Mapleton City

Planning Commission Staff Report

Consideration of a Preliminary Plat application for "Dallin's Subdivision", a 13-lot residential subdivision located at approximately 1400 East 1200 North in the A-2 and RA-2 Zones.

MAPLETON CITY DEVELOPMENT REVIEW COMMITTEE MINUTES

DALLIN'S SUBDIVISION

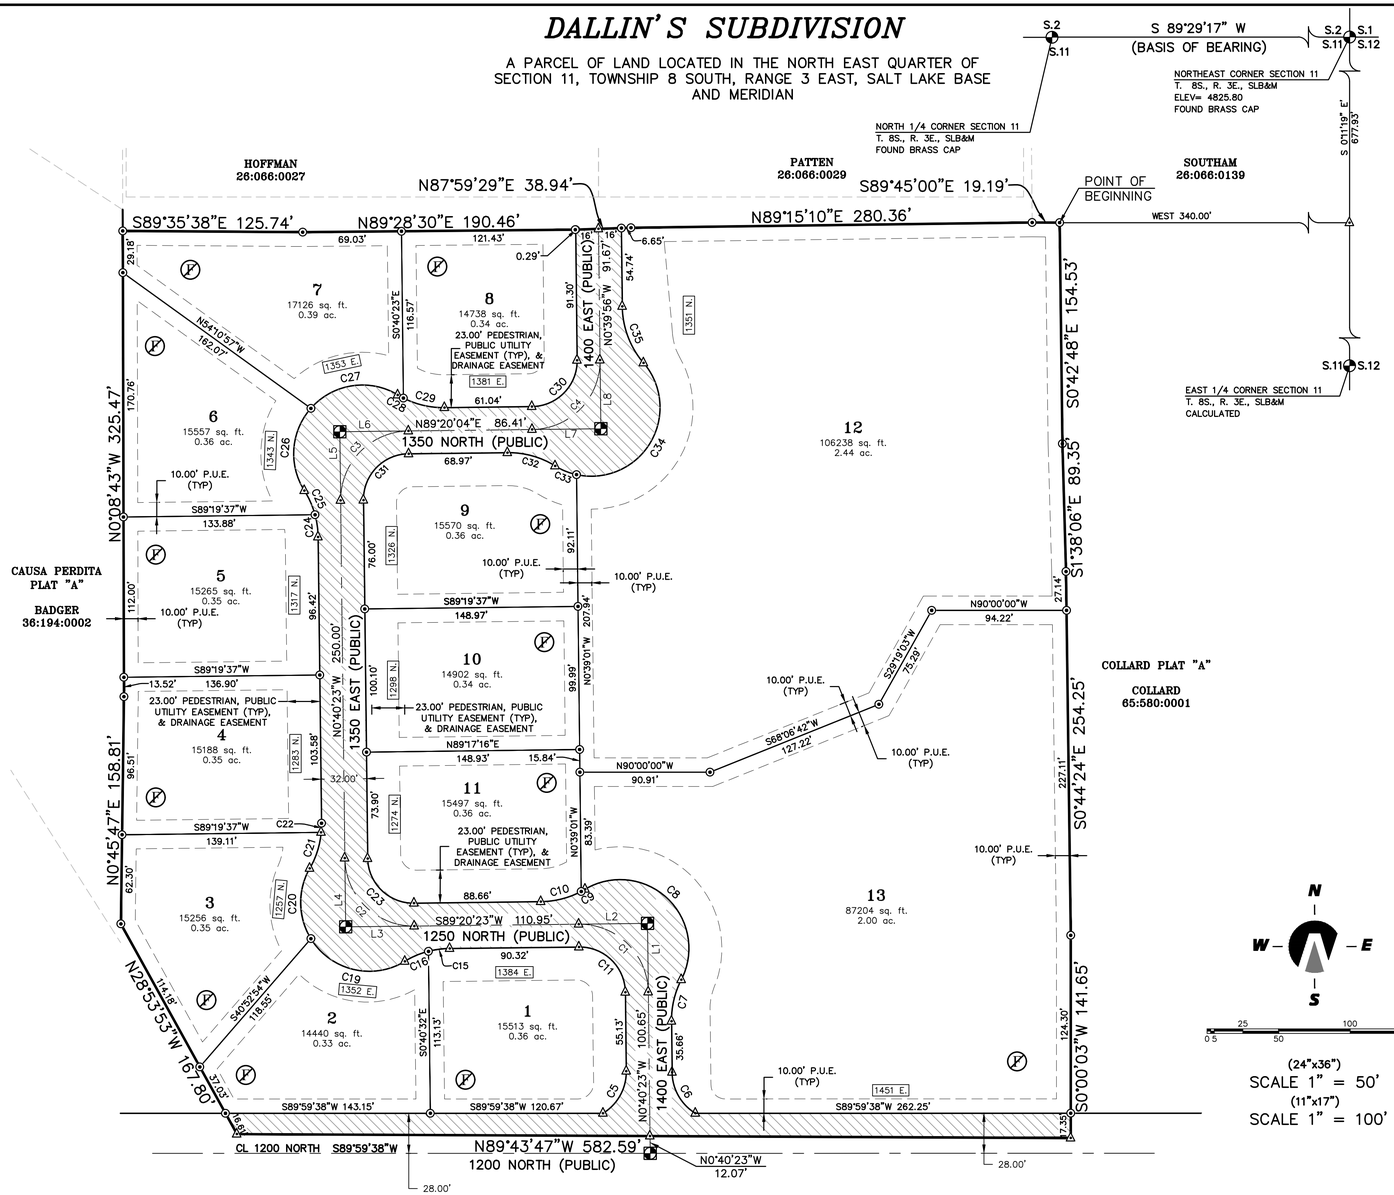
1. The final plat must include, among other requirements, the following:
    a. A final plat stamped and signed by the Surveyor of Record.
    b. A dedication block and signature lines for all property owners. The owners will need to sign the plat exactly as they signed the deed to the property and must print their names underneath their signatures to match the signatures. In addition, properties in trusts must include the title of the signer, the full name of the trust and the date of the trust.

c. The owners dedication must be accompanied by a line for the notary sign the plat, a line for the notary to print their full name, their commission number and the words "A notary public commissioned in Utah" in the signature block. **A corporate acknowledgement for Whiting Cove Development has been inadvertently provided.**

d. A signature block for the Community Development Director to approve the plat.
    e. Addresses must be shown on the final plat.

f. In accordance with the standards of the Utah County Recorder, **a space must be reserved near the bottom right hand corner for the recording certificate to be printed on the plat**. The current plat doesn't make space for this certificate. Please communicate with the Utah County Recorder's Office for the specifics for this requirement.

g. In accordance with the standards of the Utah County Recorder, the names of the Owners must be printed in the Acknowledgement as the persons who appeared before the notary. It is useful for the plat to contain a space within the acknowledgment text for the names to be written. Other standards may apply for trusts and corporations. Please communicate with the Utah County Recorder's Office for the specifics for this requirement.

h. There is no need for a signature block for East Bench Irrigation, Questar, Rocky Mountain Power, Century Link or Comcast. Mapleton Irrigation is the only "utility" that needs a signature block.

2. An assigned address list is attached to these comments. Please label the lots accordingly.
3. Boundary Line issues exist between the subject parcel and the Hoffman, Patten, Badger and Collard parcels. These will need to be resolved prior to recording the plat.
4. Course Directions in the Boundary Description do not match those on the plat. N W becomes S E and vice versa.
5. Compass Rose is rotated 90 degrees.

46' SECTION COLLECTOR
1200 NORTH STREET

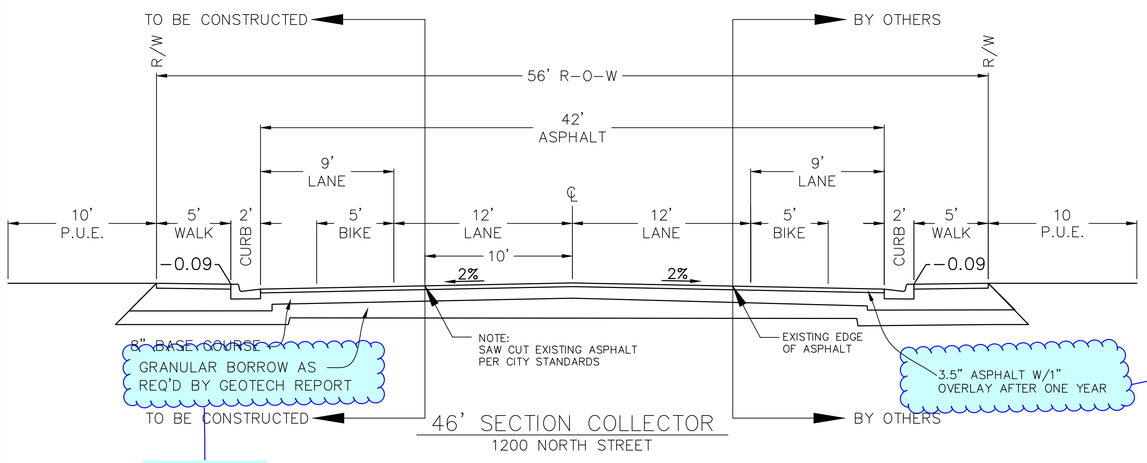
1. Please use standard Mapleton City collector cross section on 1200 N, with the exception of the planter. Property line will be the back of combination sidewalk and curb and gutter.

32' SECTION MINOR LOCAL

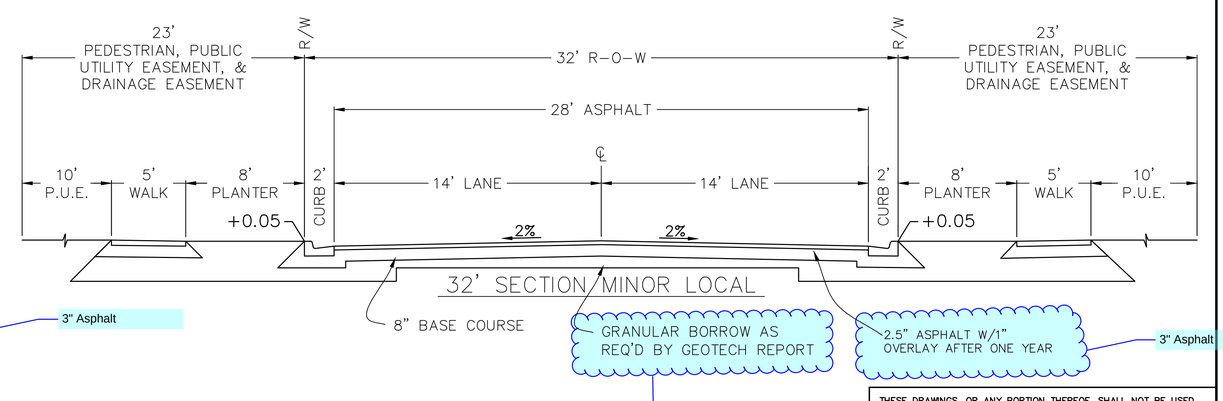
2. Please use standard Mapleton City minor local cross section on internal streets.
3. Verify that TBC alignment matches alignment in front on Elementary school to the East.
4. Please call out ADA ramps to be constructed to latest APWA standards.
5. Please straighten the north section of 1400 East to connect at 90 degrees.
